REMEDIAL ACTION FOR THE 100-N AREA

100-NR-1 TSD SITES

1	4/13/00	Issued for Construction	SEP	KEC	<i>Gay</i>	FMC
0	12/06/99	Issued for Bid	SEP	KEC	JAG	FMC
REV.	DATE	REASON FOR REVISION	ORIGINATOR	CHECKER	GROUP SUPVR.	PROJ. ENGR./DES
		RICHLAND ENVIRONMENTAL RESTORATION PROJECT	JOB NO. 22192			
			*SCOPE OF WORK NO. 0100N-SW-G0058			
			SHEET 1 of 55

**SCOPE OF WORK
REMEDIAL ACTION FOR THE 100 N AREA
100-NR-1 TSD SITES**

Figure 1

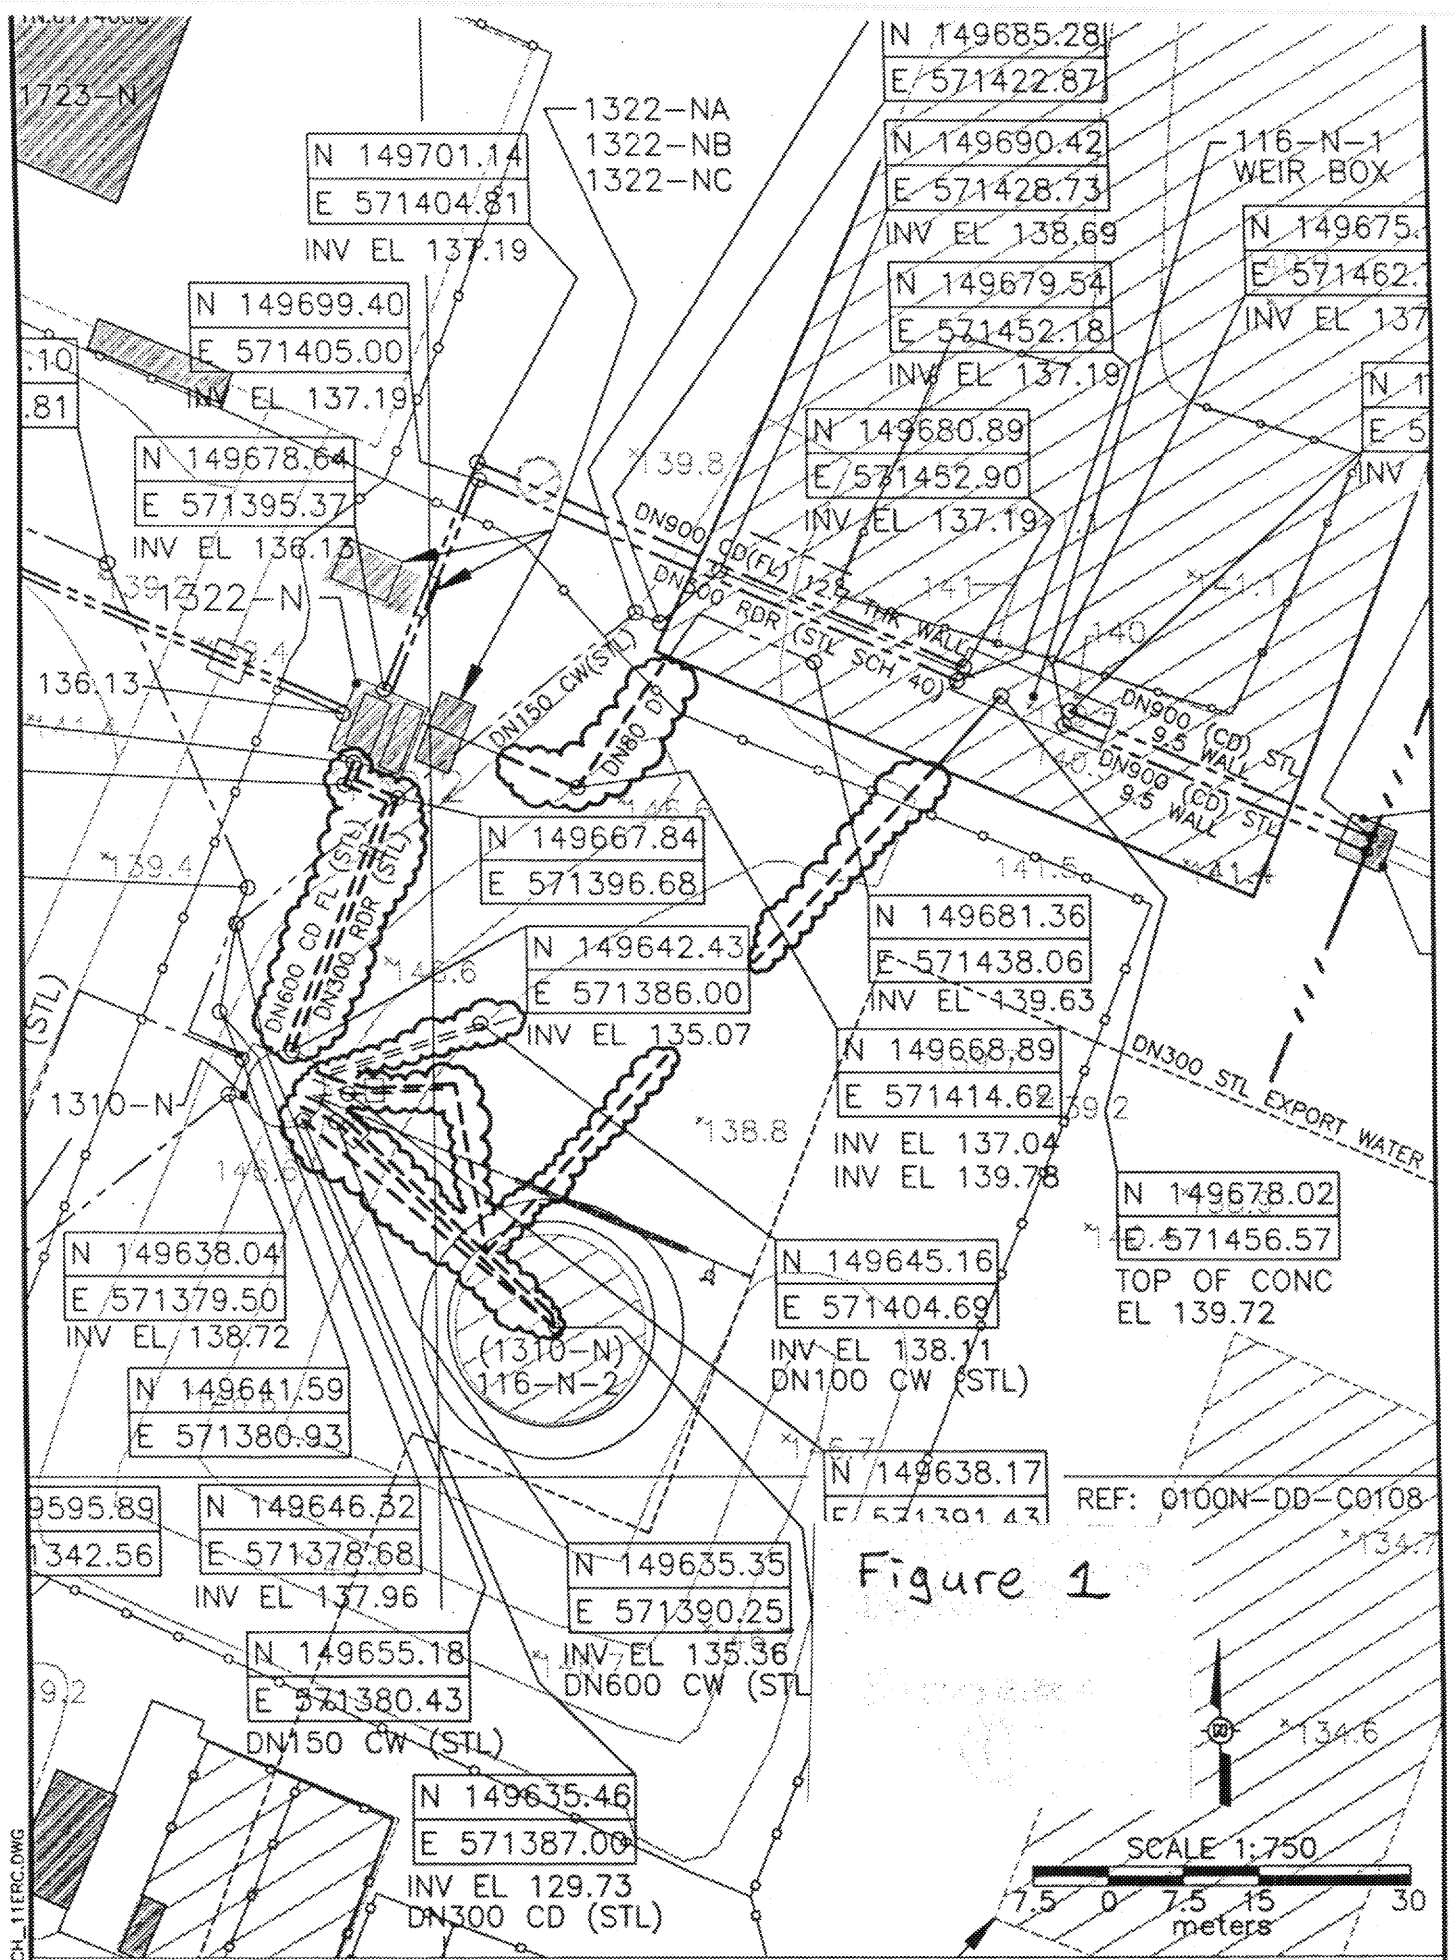
Figure 1 – Piping within the berm around the 1310-N “golfball” is deleted from this scope of work. The piping removed is “clouded” as shown on attached figure 1.

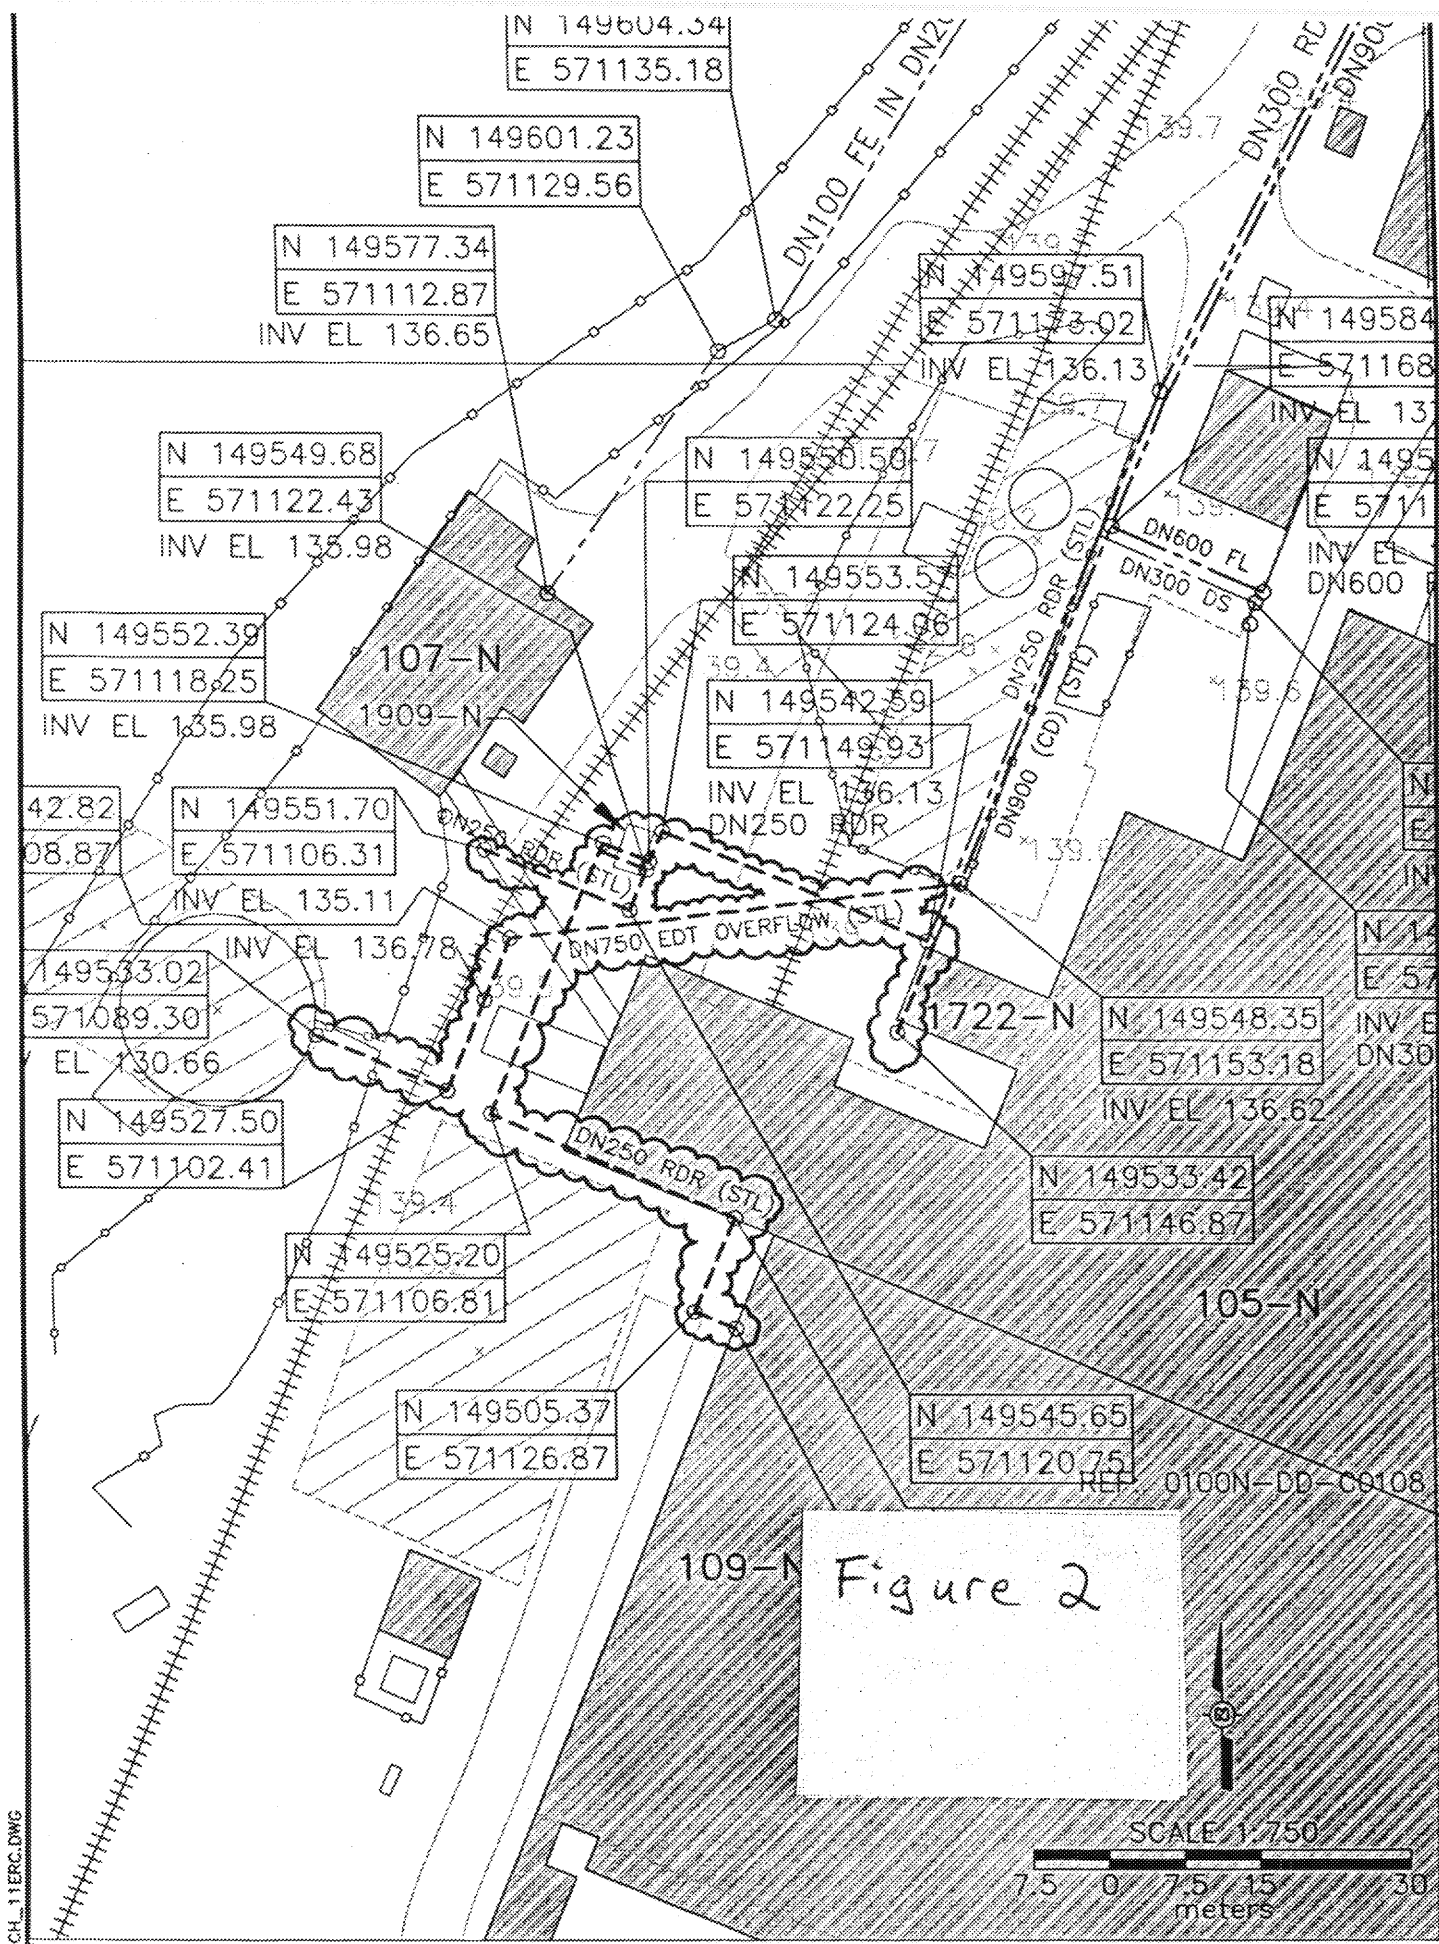
Figure 2 – The limit of the DN 250 and DN 900 pipes is the extent of the 1722 N building. All “clouded” pipe shown on figure 2 is removed from this scope of work.

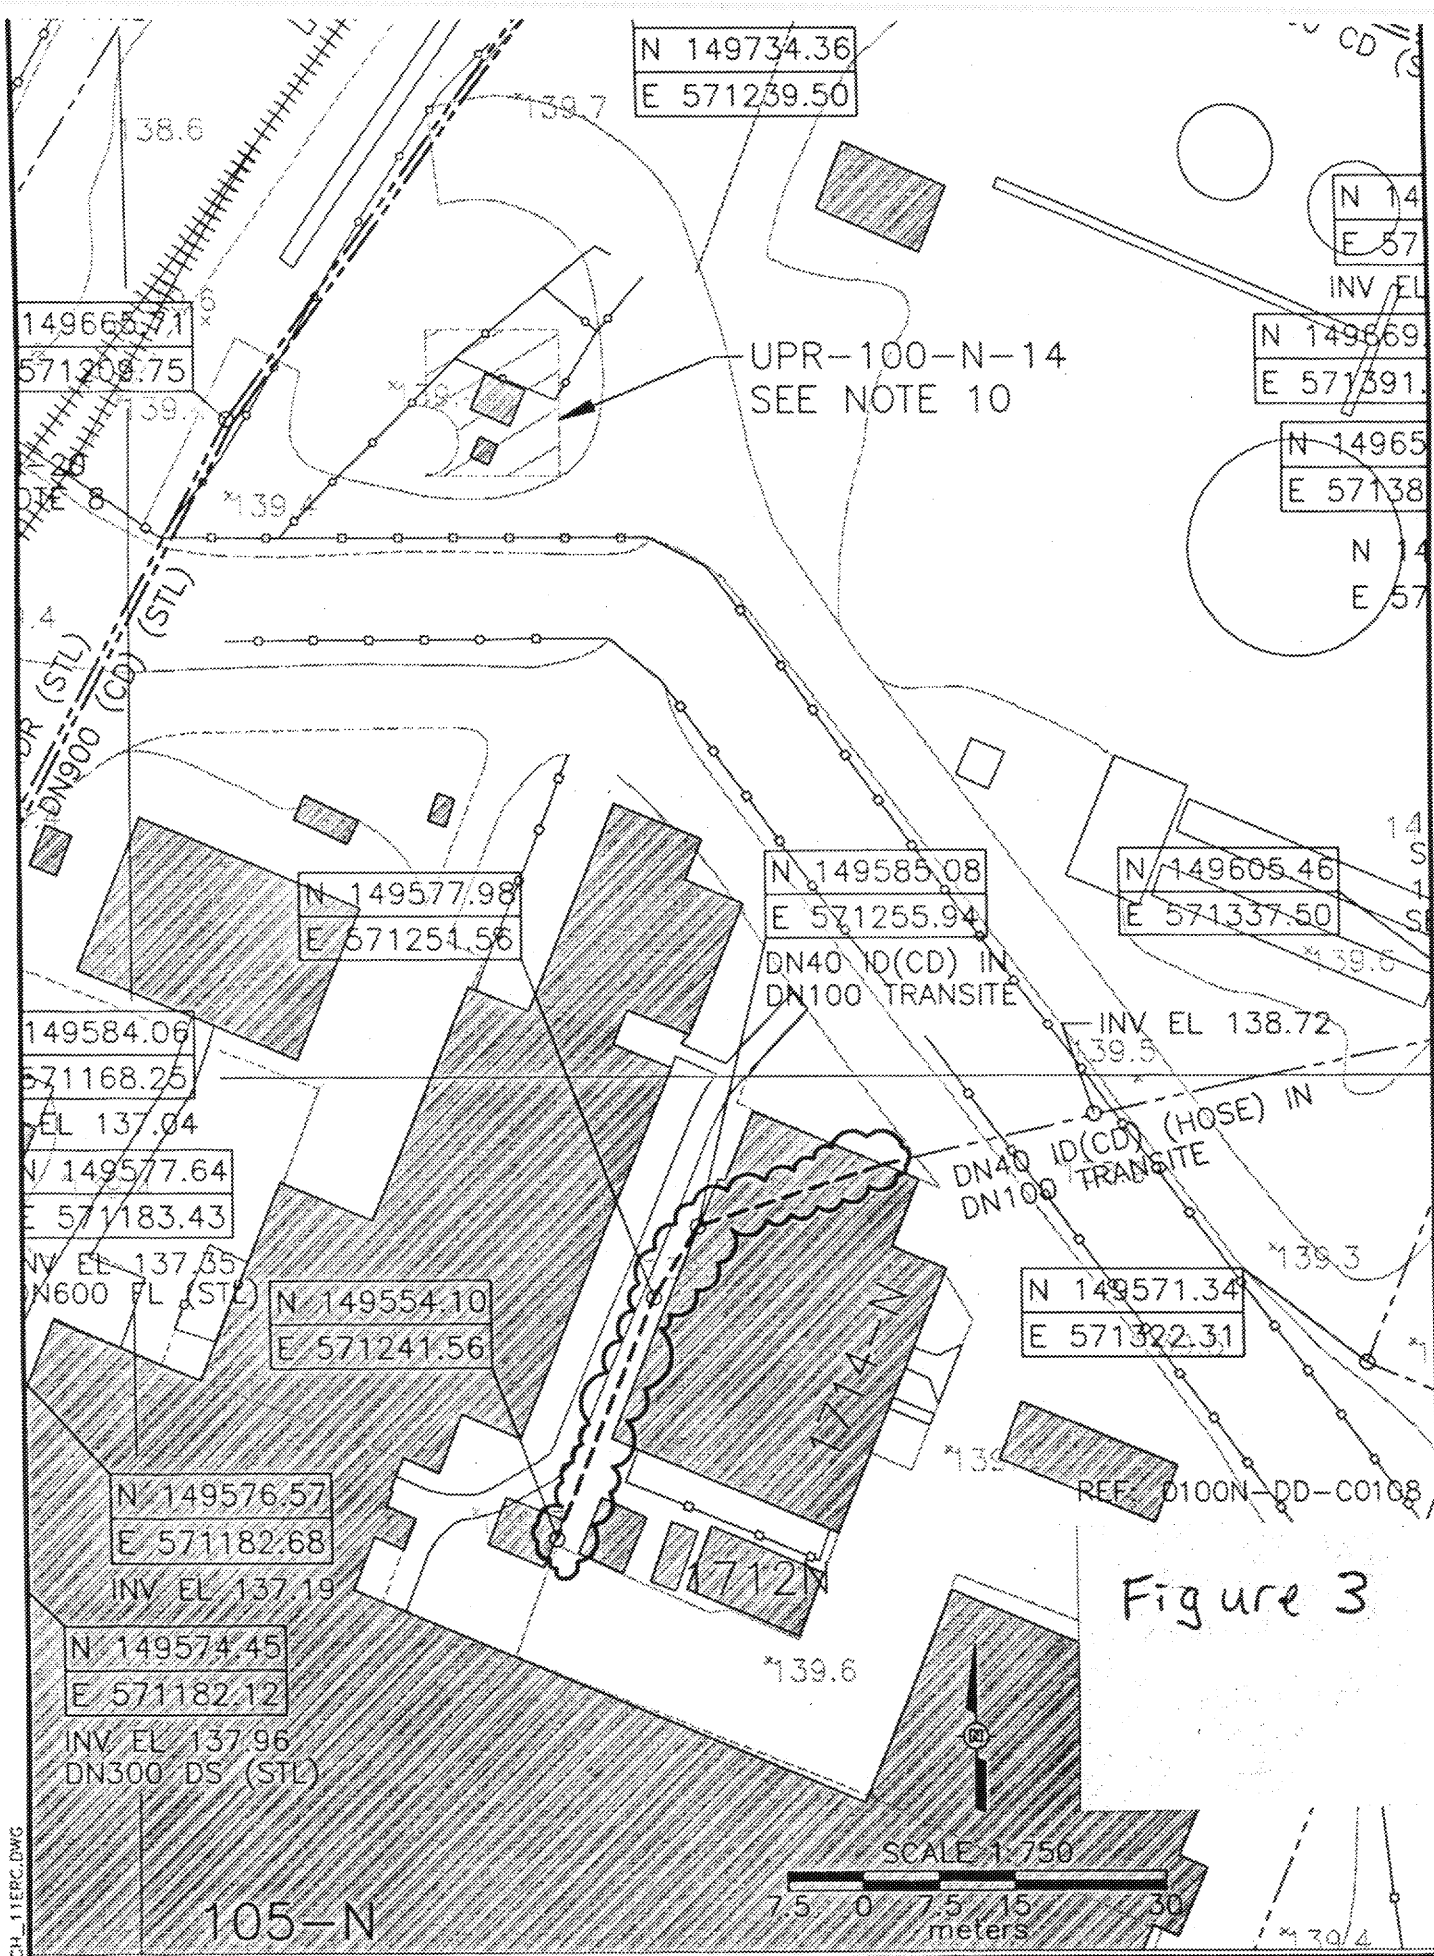
Figure 3 – The limit of the DN 40 hose in DN 100 transite stops at the 1714-N building. The “clouded” portion of the pipe shown on figure 3 is removed from this scope of work.
